MISCELLANEOUS PAPER GL-85-2

REVIEW OF RIGID PAVEMENT DESIGN FOR VEHICULAR PARKING AREAS

20. ABSTRACT (Continue on reverse side if necessary and identify by block number) This paper documents proposed changes to TM 5-822-6, "Rigid Pavements for Roads, Streets, Walks, and Open Storage Areas." Changes are recommended in the areas of impact effects, the coverage versus thickness relationship, and effects of high-strength subgrades. Additionally, the criteria for design thickness of vehicular parking areas should be changed to account for a differ- ent slab loading condition, including load transfer at joints. These changes establish a rational and consistent basis for CE design of rigid airfield and nonairfield pavements.

Figure 1. Rigid pavement design curves for roads and streets

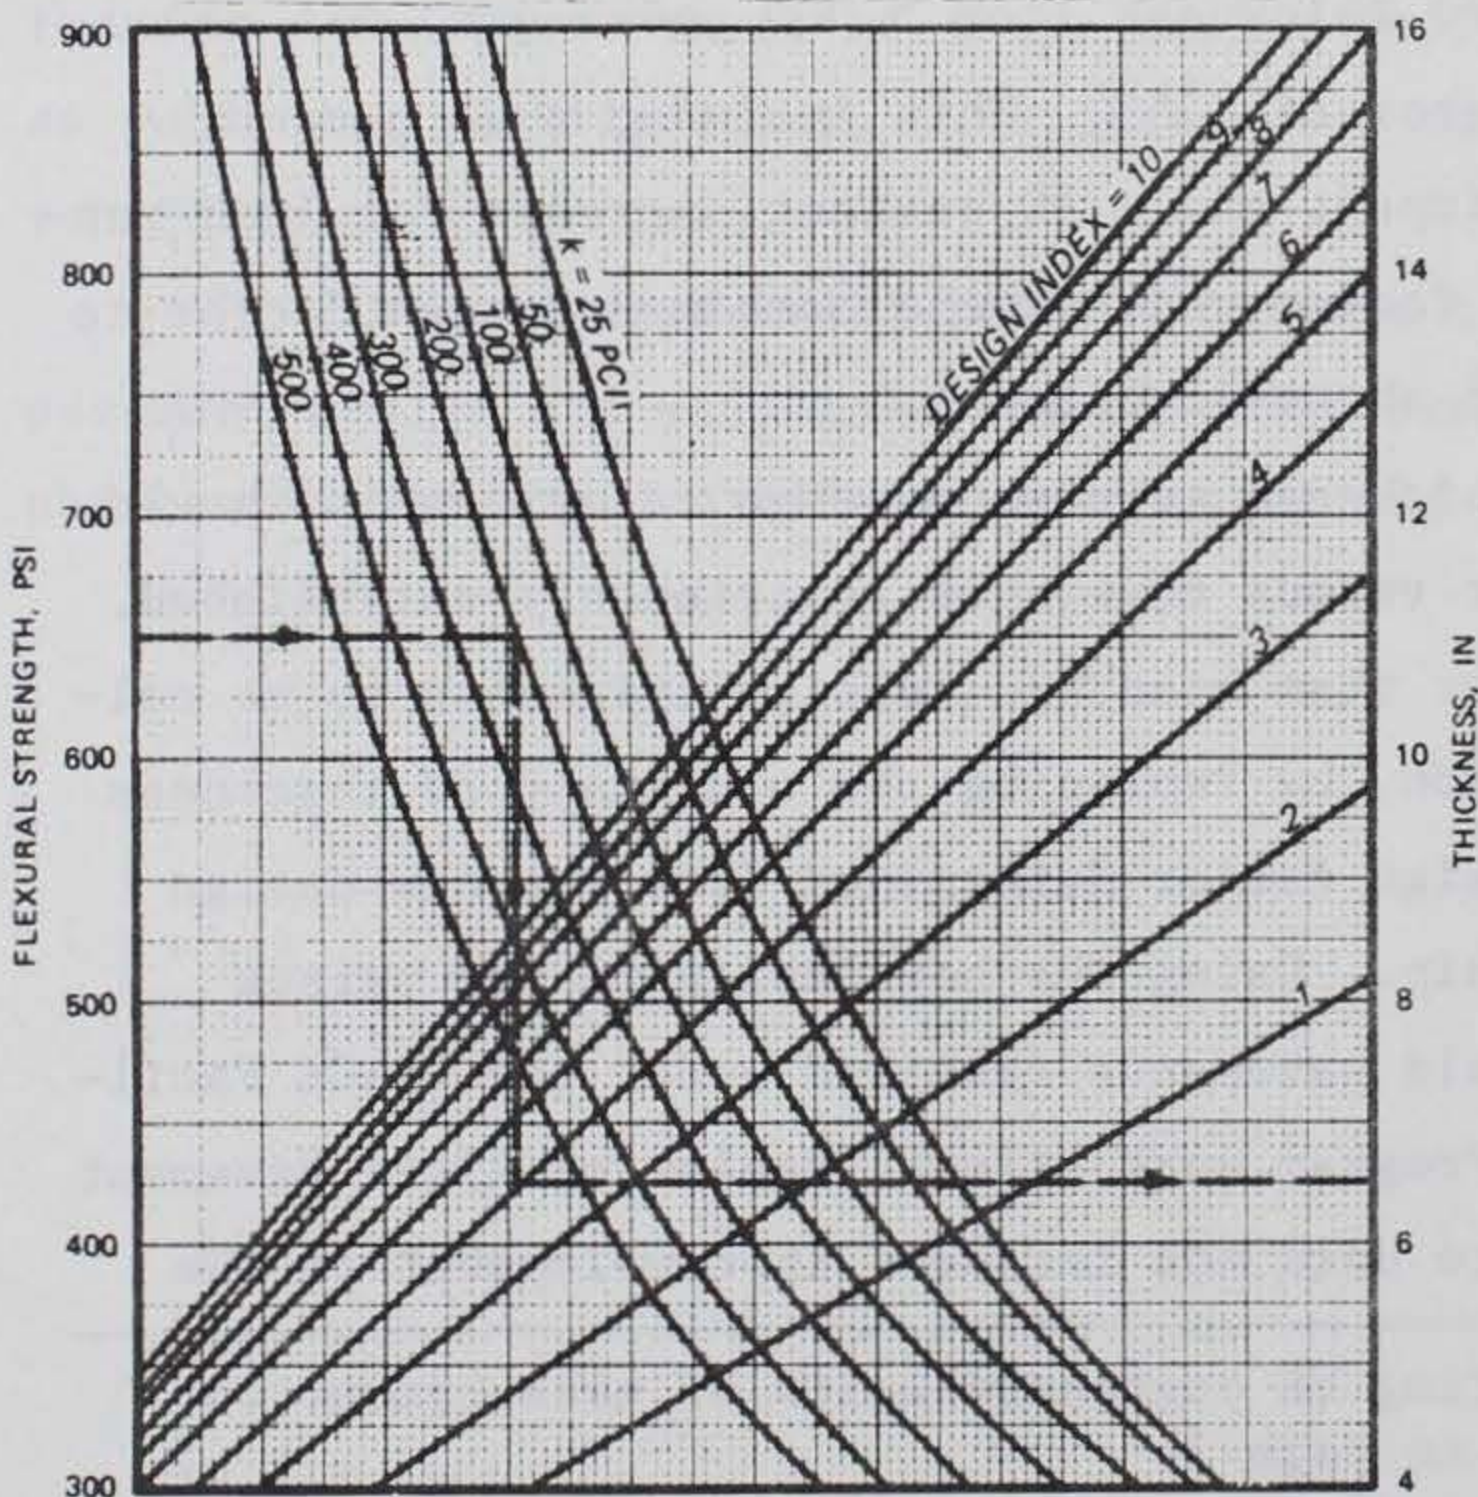
10. The cumulative change in design thicknesses of roads and streets depends upon the coverage level (design index) and subgrade strength. It varies from an increase of 9 percent to a decrease of 19 percent for typical values of design parameters. The new rigid pavement design curves for roads and streets are shown in Figure 1.

Figure 2. Rigid pavement design curves for parking areas

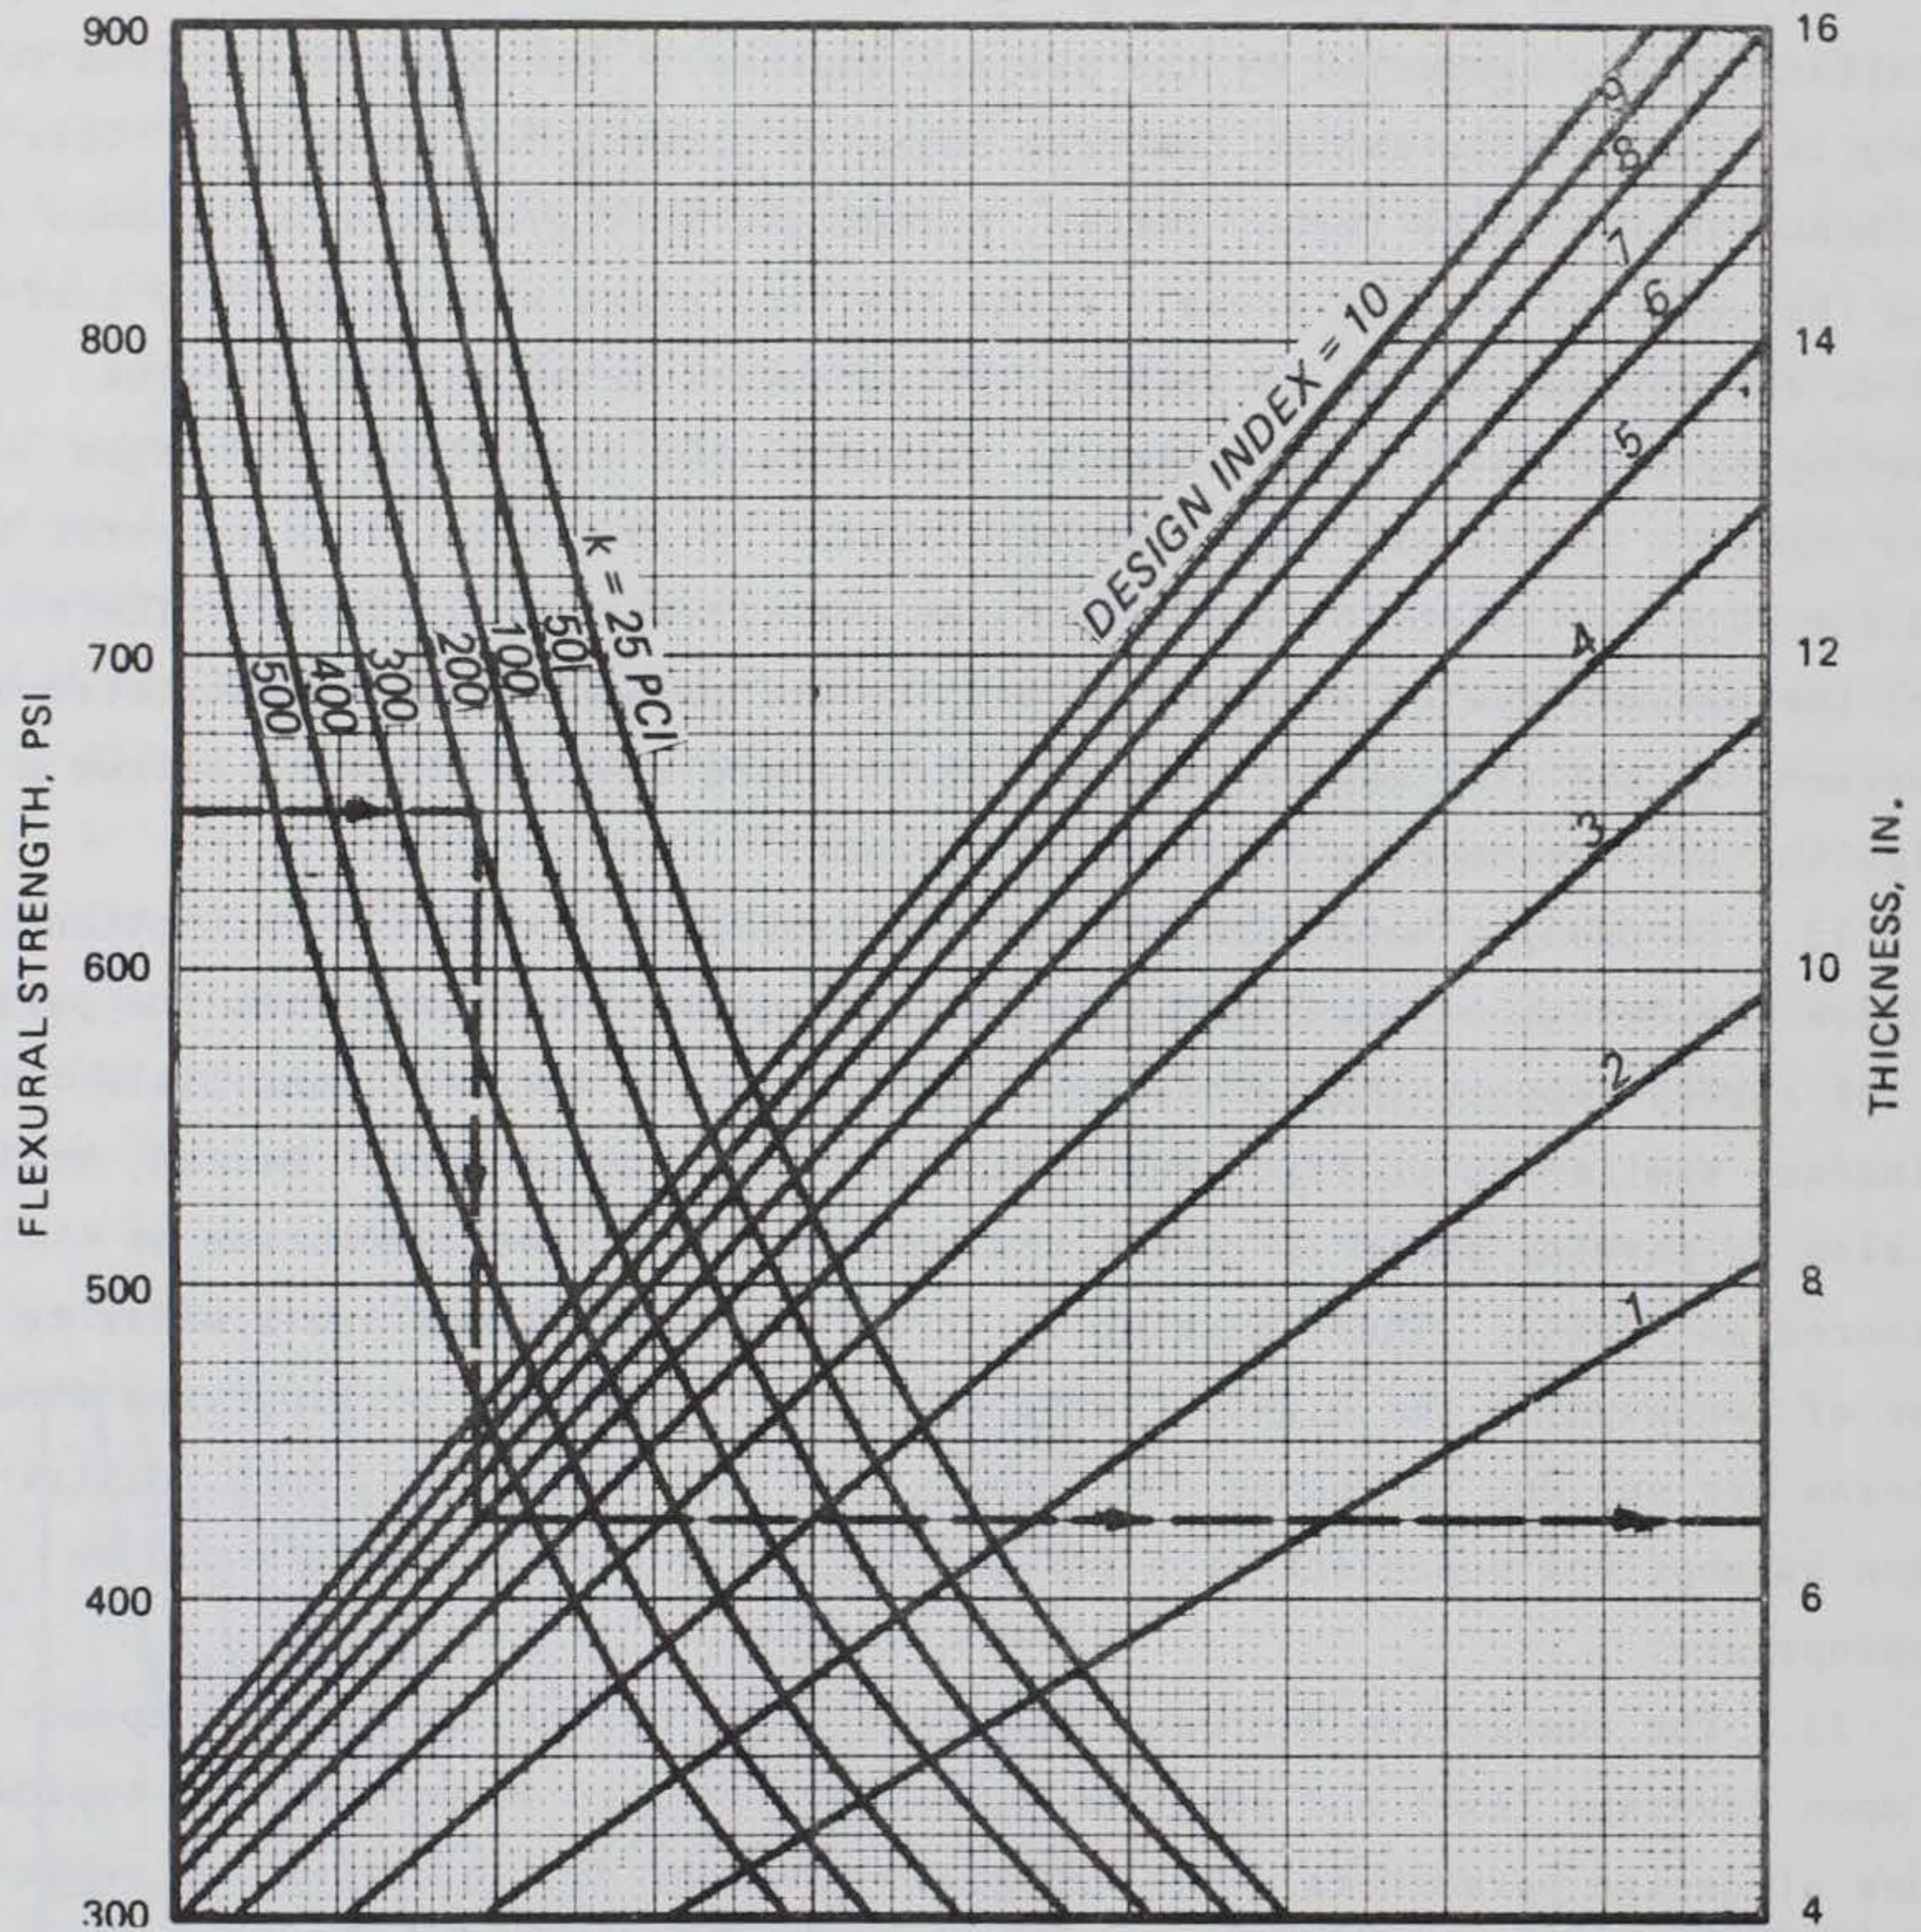
13. The cumulative decrease in parking area design thickness, depending upon coverage level and subgrade strength, is 12 to 27 percent for typical values of design parameters. The new rigid pavement design curves for vehicular parking areas are shown in Figure 2.
